**MINUTES OF
60th MEETING OF EXPERT GROUP ON ZOO DESIGNING
OF CENTRAL ZOO AUTHORITY
HELD ON 1st MAY, 2015**

a. Design of proposed exhibit for Jackal:

PROJECT
 PROPOSED ENCLOSURE FOR JACKAL
 AT BIOLOGICAL PARK, ITANAGAR

TITLE
 KEY PLAN

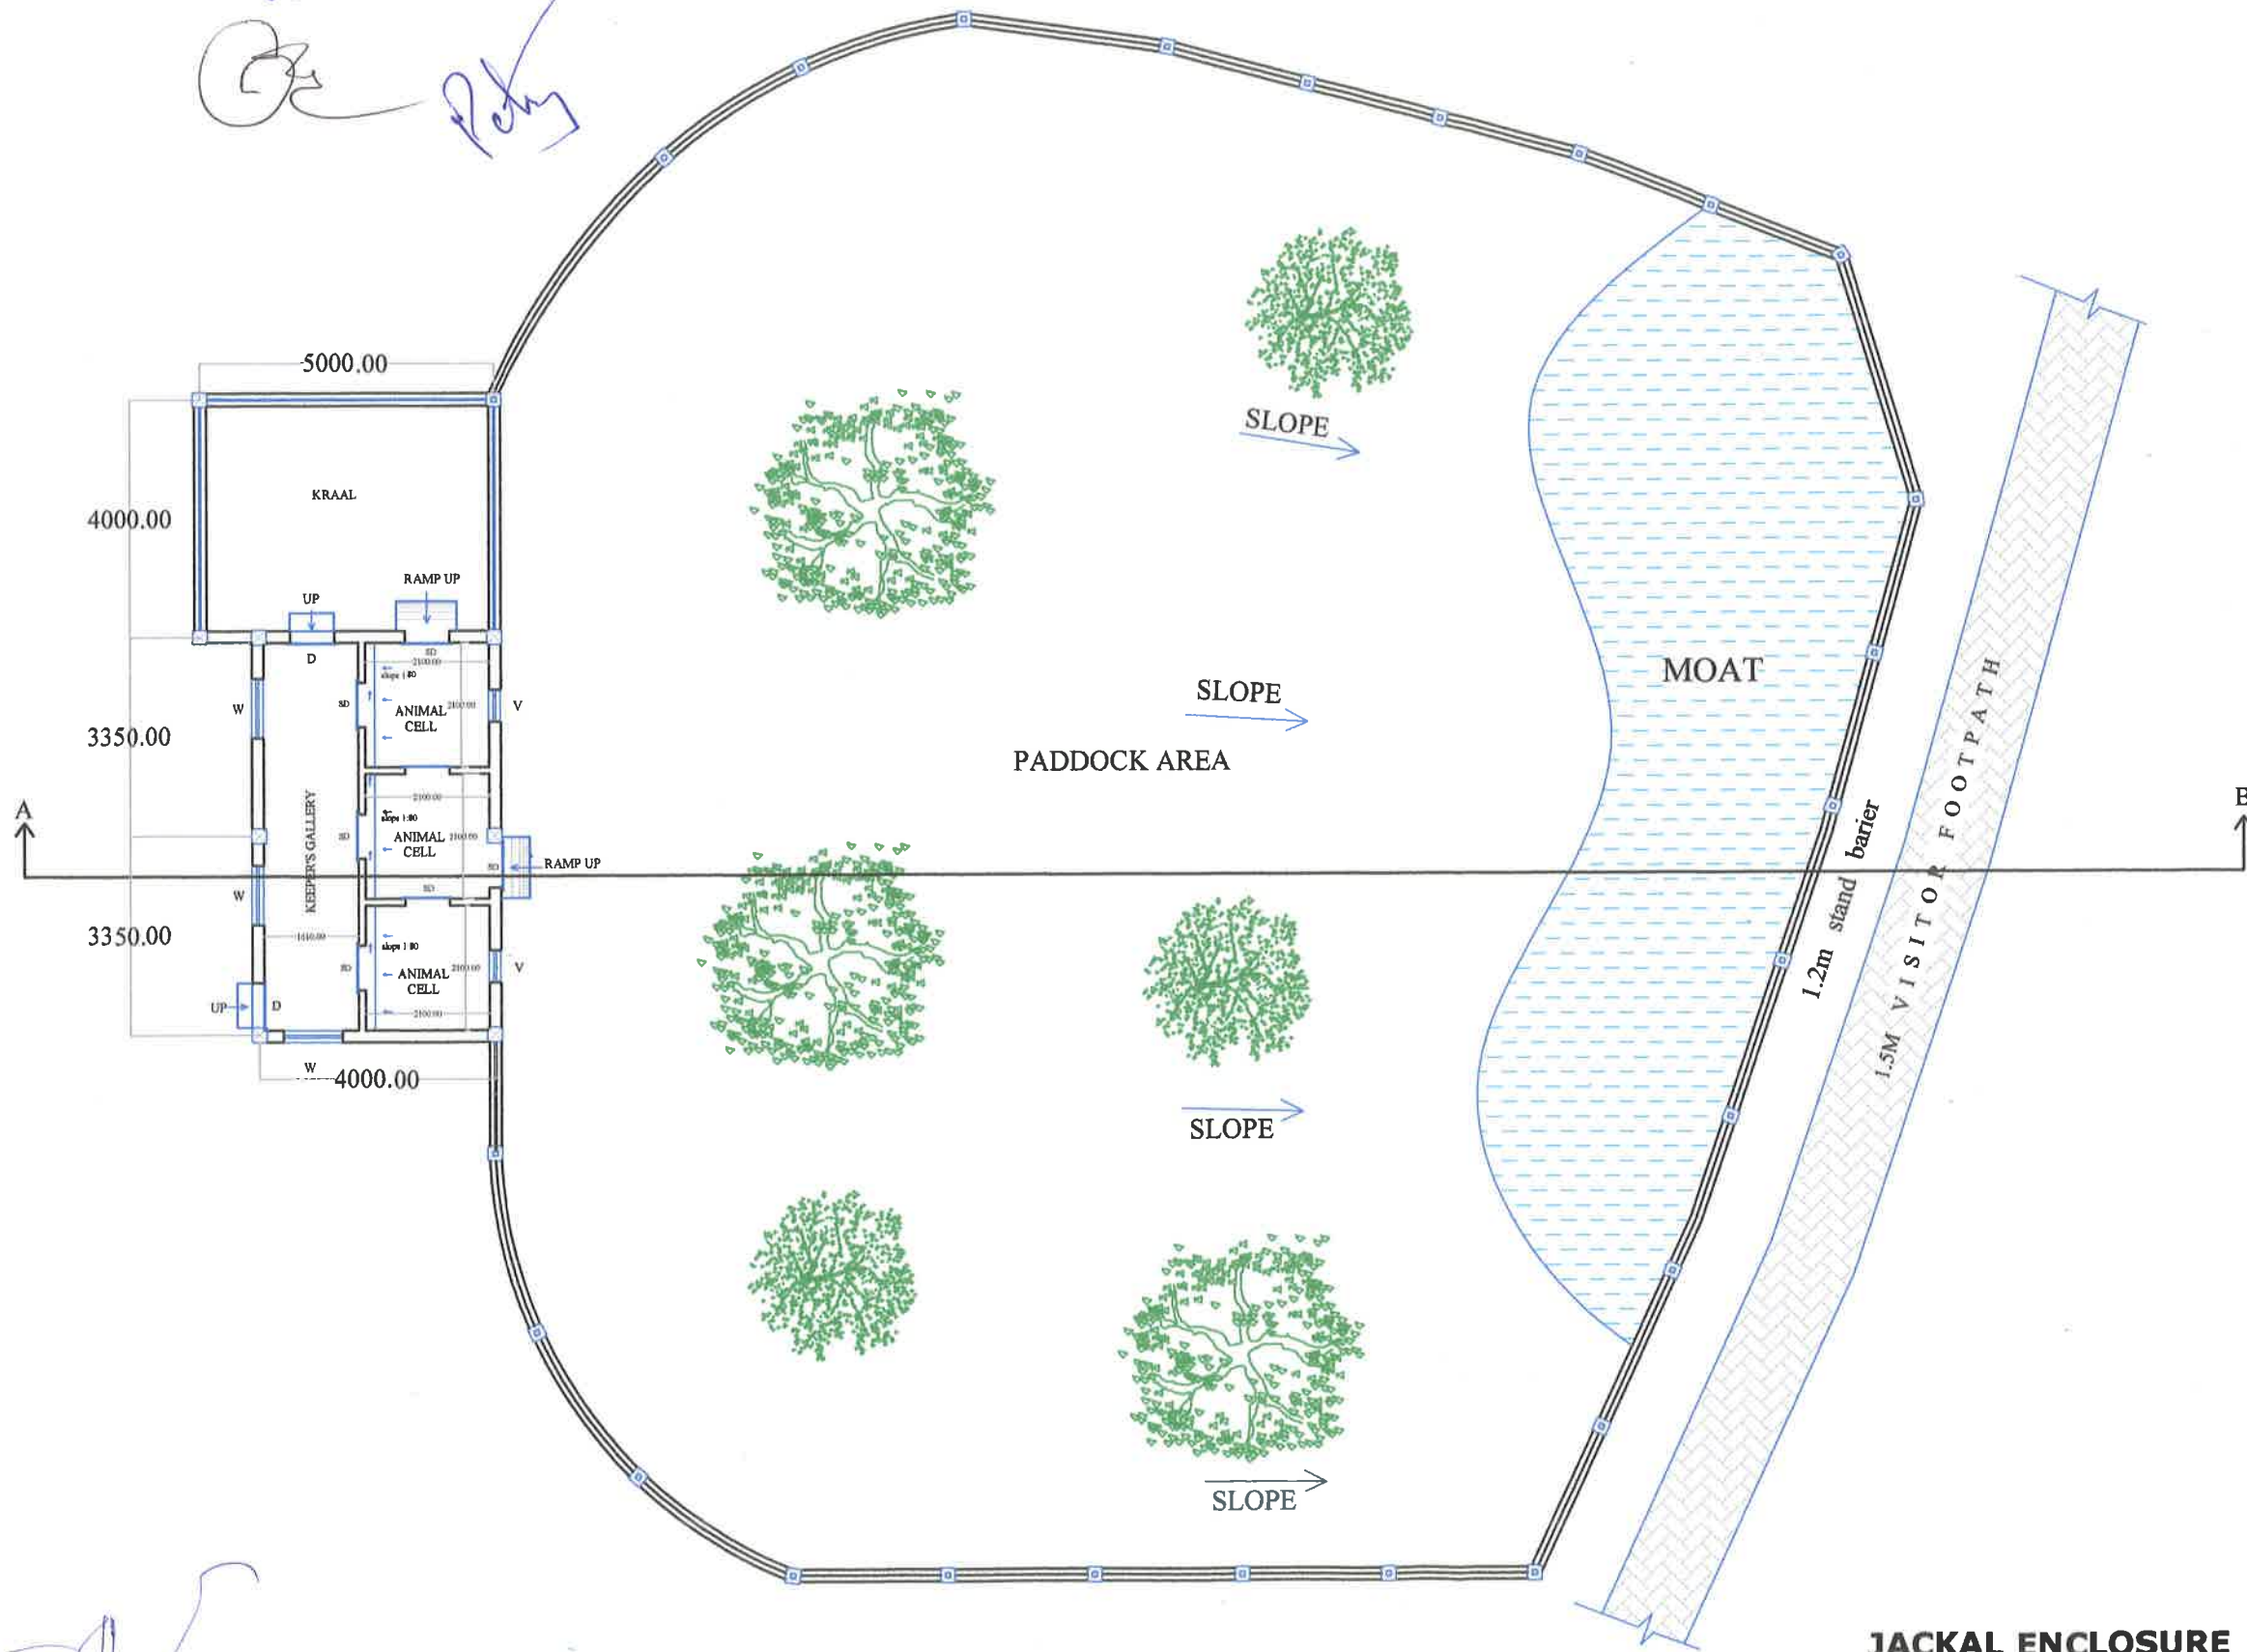
① Though it is not clear, but the moat should be dry moat and raw water if collected should be drained out.

- i. Exhibit should have dry moat and rain water if collected should be drained out.
- ii. Size of sliding door should be 60 cm x 90 cm.
Size of entry door should be 1.2 m x 1.8 m.
